O2

Gladstone Road NW

Land Use Amendment (LOC2020-0122)

Outreach Summary

1110 - 1126 Gladstone Rd NW

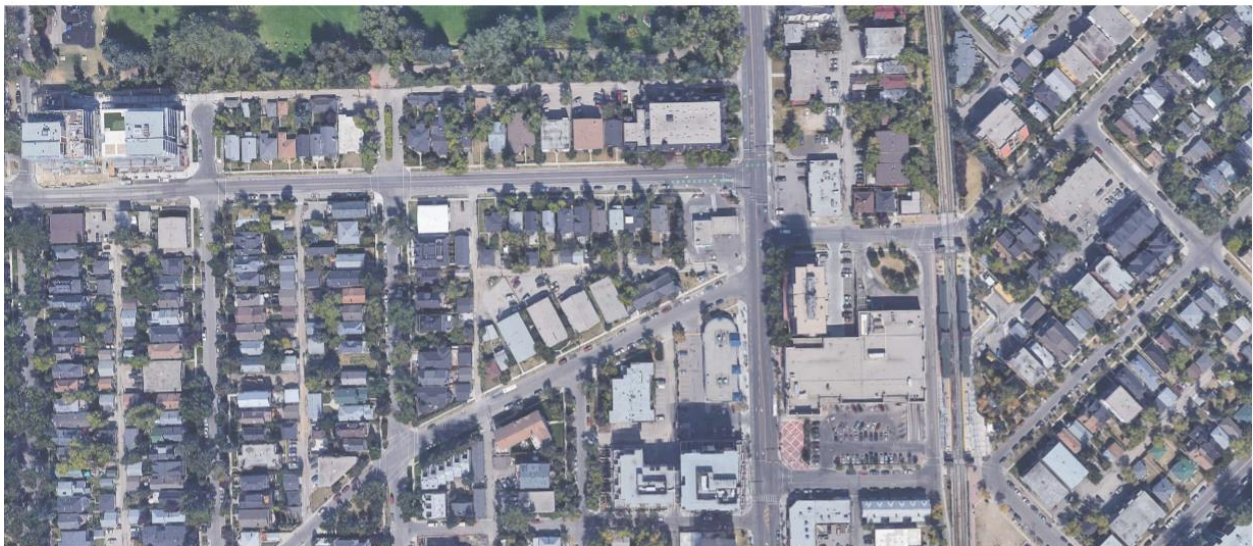
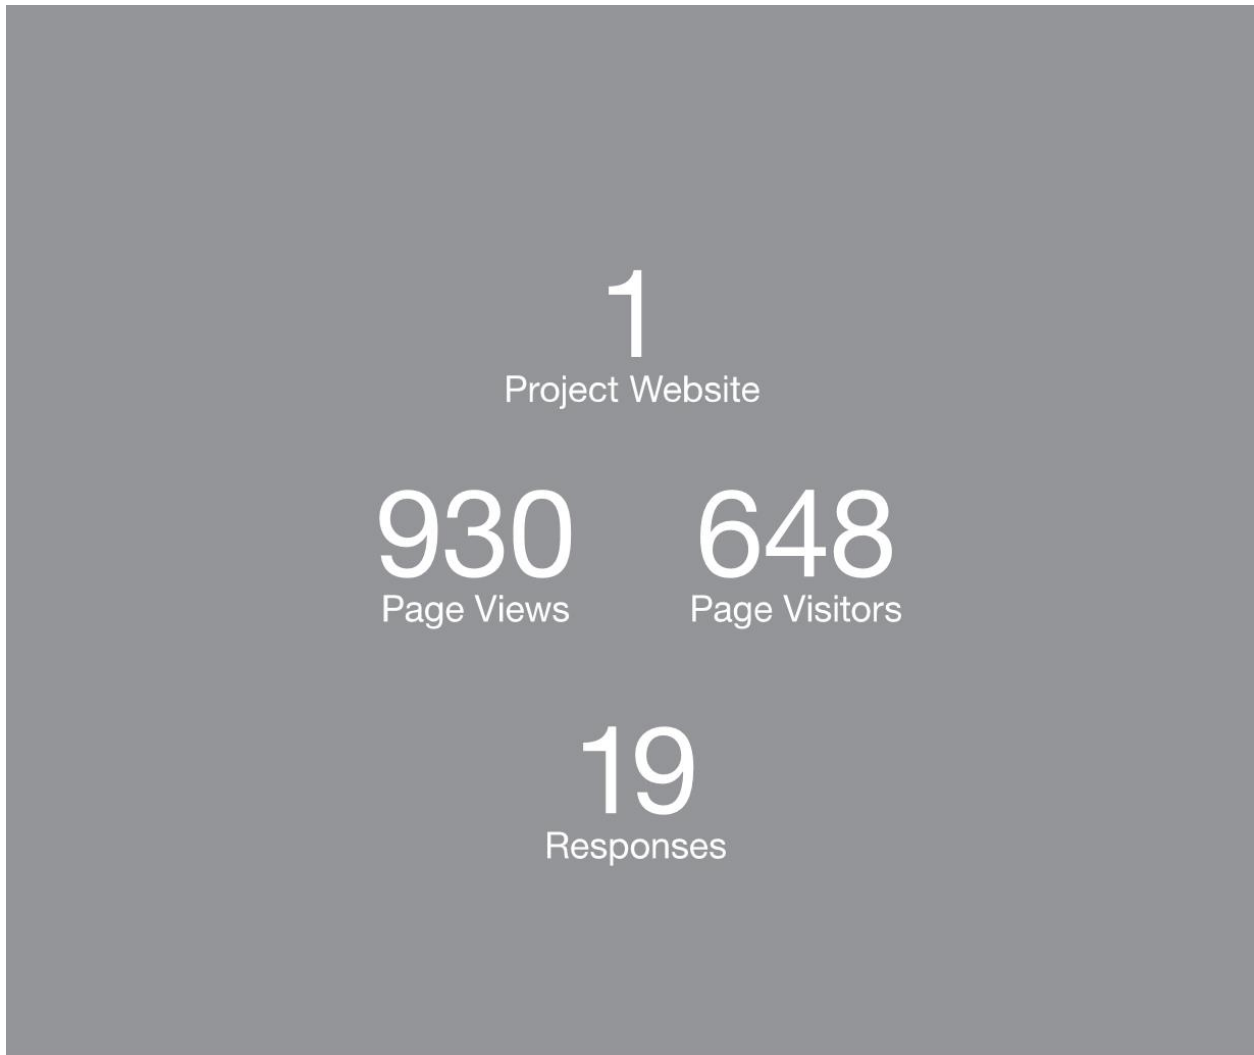
Questions: What will I see when I look north from my house? I don't see a rendering of the view up 10A St looking north. The previous developer had a plan for a massive block of built environment that overpowered the street. What is your vision for the streetscape looking north up 10A? Will the suites be small and designed for utilitarian transition housing until the renter can afford to move out and up in the world? As a community, I have an interest in families moving in, people coming to make our neighbourhood their home for the long term, shopping locally, and taking care of the places they walk through. That requires suites suitable for growing needs as people's lives change over time. With 4FAR, will there still be units that families can rent as long term homes?

Looking at the rendering I cannot tell if the ground level units have a place to sit outside and interact with passers by. I really feel that the semi private space outside of a building makes or breaks how the structure interacts with its surroundings. The walkability of this location means that having people out on street level patios help create a strong sense of community.
